SUBJECT: ISSUANCE OF AMENDMENT NO. 68 TO FACILITY OPERATING LICENSE
NO. NPF-29 - GRAND GULF NUCLEAR STATION, UNIT 1, REGARDING
FIRE DETECTION INSTRUMENTATION (TAC NO. 76152)

TABLE 3.3.7.9-1
FIRE DETECTION INSTRUMENTATION

SAFETY EVALUATION BY THE OFFICE OF NUCLEAR REACTOR REGULATION
SUPPORTING AMENDMENT NO. 68 TO FACILITY OPERATING LICENSE NO. NPF-29
SYSTEM ENERGY RESOURCES, INC.
GRAND GULF NUCLEAR STATION, UNIT 1
DOCKET NO. 50-416

AUXILIARY BUILDING
FIRE PROTECTION
PLAN AT EL. 185FT-0IN
AREA 10

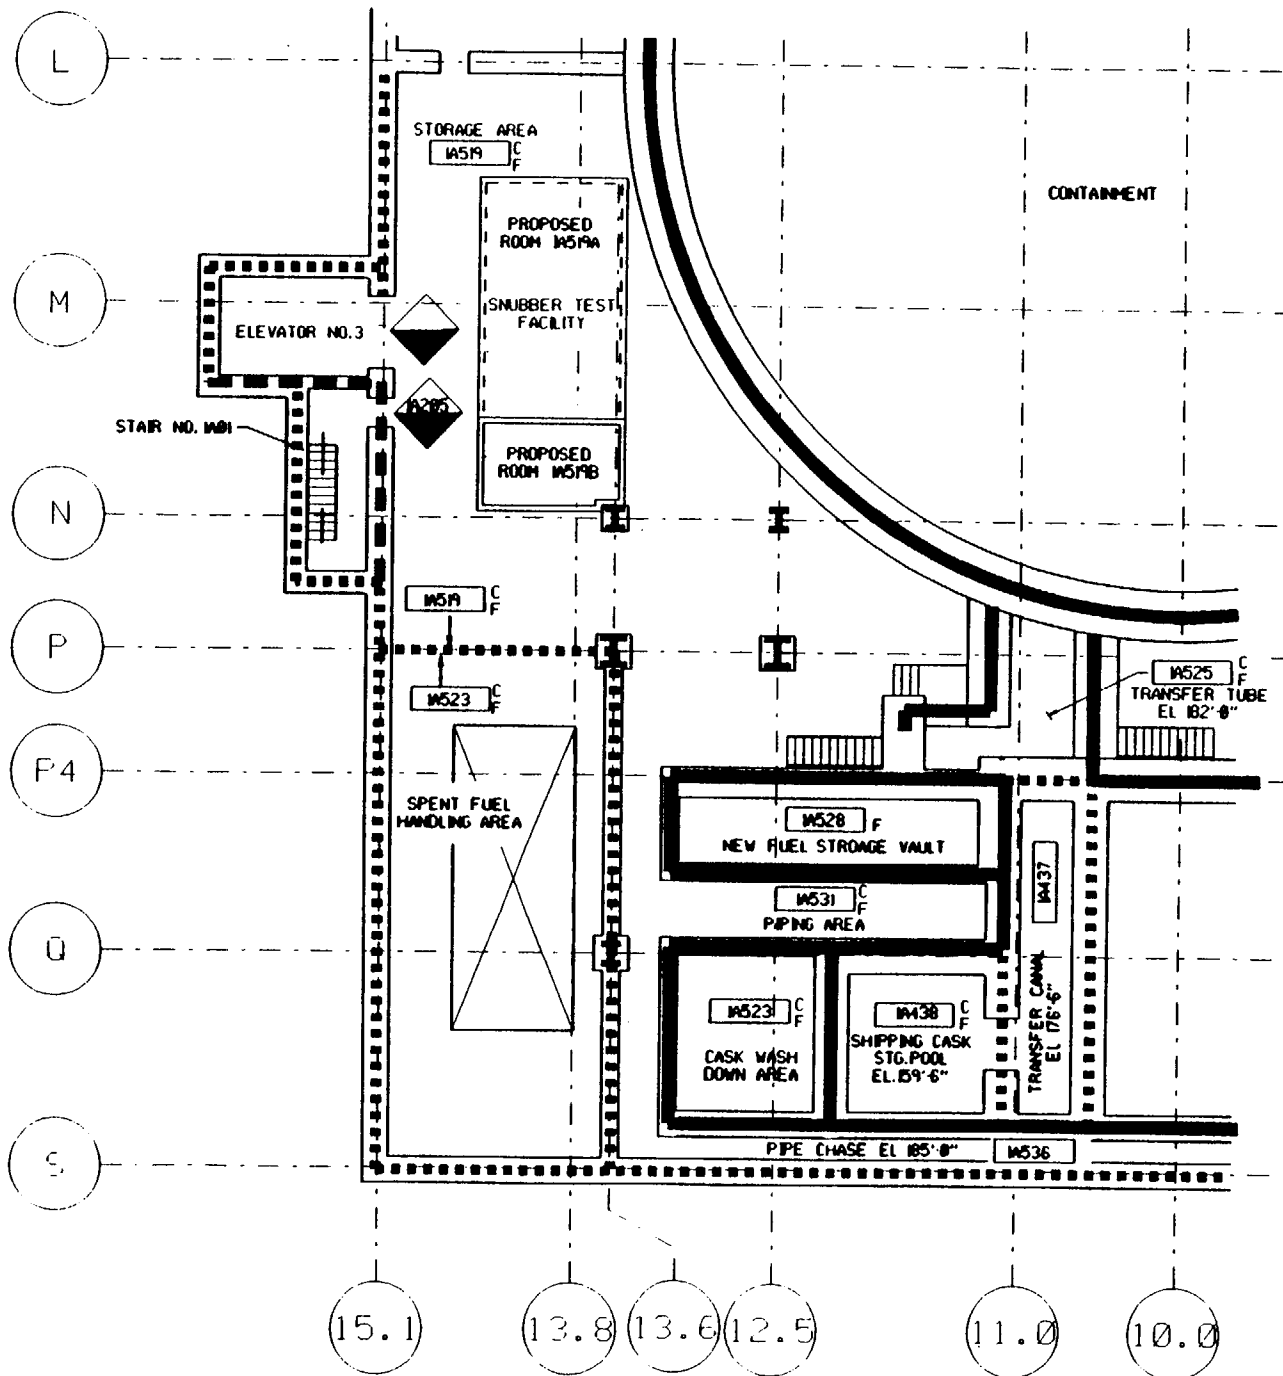
Table 3.3.7.9-1 would also be revised to reflect a design change to construct a nonsafety-related, permanent facility to house snubber test equipment and personnel necessary to test snubbers in accordance with Technical Specification 3/4.7.4. This new, totally enclosed facility would be located in Fire Zone 1A519 of the Auxiliary Building at elevation 185'-0" and would also be partitioned into a Snubber Test Room and a Snubber Test Control Room. Figure 1 provides a general layout of the facility. The snubber test facility would be located within Fire Area 19 which contains some safety-related equipment and fire detectors exterior to the proposed facility. Since this enclosure could effectively isolate

a fire occurring inside the snubber test facility for an indeterminate period of time, this design change includes the addition of a detector in the Snubber Test Room and the addition of a detector in the Snubber Test Control Room. Table 3.3.7.9-1 would be revised to reflect the additional instruments in Detection Zone 2-9. The snubber test facility would be nonsafety-related and would not house any safety-related equipment. To minimize impact on fire protection, all construction and finishing materials would be non-combustible as defined in the Fire Hazards Analysis. The Fire Hazards Analysis for the facility assumes a heat load based on a 30 gallon drum of flammable fluid and office furniture, including a file cabinet filled with paper in the facility. The smoke detector in each of the two rooms would provide early warning and thus reduce the potential for fire damage to safety-related equipment adjacent to the snubber test facility. The two smoke detectors, along with accessibility to existing manual hose streams and portable fire extinguishers, would provide fire protection capability for this facility equivalent to that provided for the rest of the plant. Therefore, the TS change is acceptable.

8. Zone 2-9					12/0
1A519	185'	Storage Area			
1A519A	185'	Snubber Test Room			
1A519B	185'	Snubber Test Control Room			
1A524	195'	Platform			
1A527	185'	Load Center Area			
1A529	185'	FPC & CU Rm.			
1A538	185'	Platform
